> Product Change Notification (PCN)

Product group:	MINISKIIP II	Rev.:	0
No.:	PN21-085	Update of technical documents	17 Dec 2021

Subject of change: Technical explanation and datasheet update

SEMIKRON
product type: MiniSKiiP 2nd Generation

Current datasheet drawing

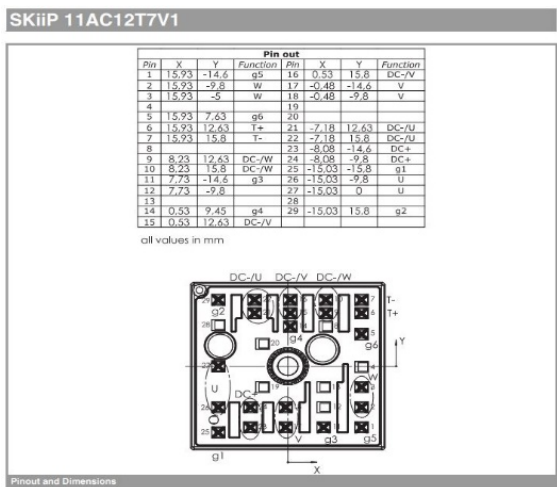
2.1 Replacement of the drawing in the datasheets
